S No	Wickham Market Committee comments	Image	Google Link	WSP Response
				The standard width of a bus is approximately 2.55m. The narrowest carriageway width in this location is circa 6.2m, which provides sufficient clearance for two buses to safely pass one another except at the proposed build-out location. In the event when two buses are stopped at the two bus stops at the same time which would not happen too often during the day. Vehicles will still be able to go pass them.
1	Sheet 2 - Would there be an issue if 2 buses used the 2 bus stops just west of Morris Road at the same time? (Does the mainline bus service operate more than 1 bus?) Request for SCC standard detail drawings; visuals of kerb build-outs and reflective bollards; support for footway widening (seems SZC)		B1438 - Google Maps	Snip – Two buses parked and one car going around CONTRU C

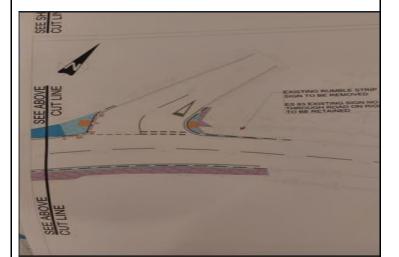
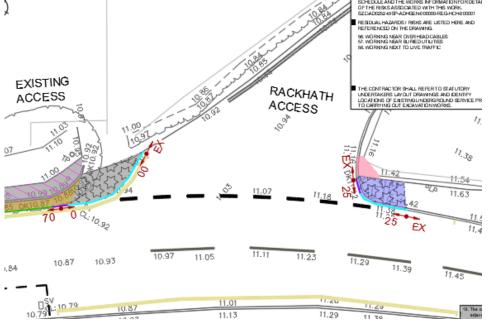
I'd particularly highlight the concerns from Rackham's about proposed alterations to their access. They have current challenges for their lorries to access or egress their premises (seems SZC)

The key shows that the proposed works around the south side of the entrance include 30mm overlay (dark blue) and 20mm overlay (light blue) on top of the access surface with 50mm high kerbs. This would square up the access which is better for pedestrians but due to the thin overlay I'd assume this would allow lorries to over-run it (which we can confirm with WSP).

We understand your concerns and as a result we are proposing to almost leave the junction/ access as is. However, we will propose minor adjustments to the footpath to improve pedestrian visibility crossing the road. Please see below schematic of the new proposal.
